# **176 Loma Alta Proposal**

## **Response from Blake & Jessica Thornberry**

3/7/2025

THORNBERRY  
176 LOMA ALTA AVENUE  
LOS GATOS, CA 95030

View of [REDACTED] from backyard of 176

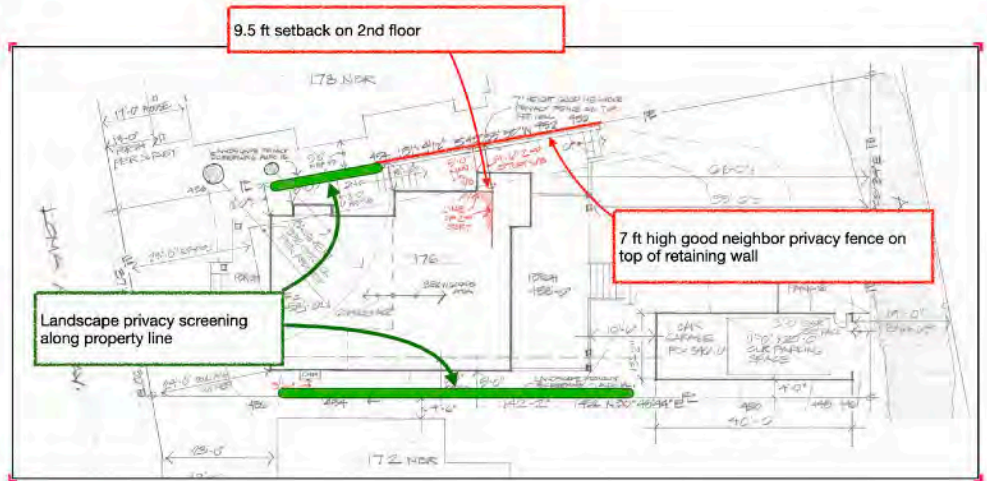
Currently, [REDACTED] Loma Alta has a two-story house with unobstructed views of our property and dwelling. (see photo below)

[REDACTED] Loma Alta has a large side window 4'6" from the property that looks into our property and dwelling. (see photo below)

Both [REDACTED] and [REDACTED] were constructed decades after our existing dwelling. Minimal consideration for privacy was given during their construction. With our proposal, we seek to improve the privacy situation for all. (see diagrams below)

176 Loma Alta | Privacy: Windows on 172 side

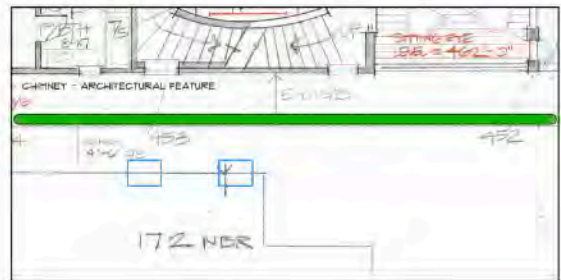
- Design and privacy screen will address the privacy concerns

- Will be shielded by landscaping privacy screen

- Will be shielded by landscaping privacy screen
- Kid's window doesn't face any neighboring window
- 2x staircase windows at the top landing do not face any neighboring windows
- 2x staircase windows away from the landing cannot provide line of sight to neighboring windows because they are too high from the floor of the descending stairs
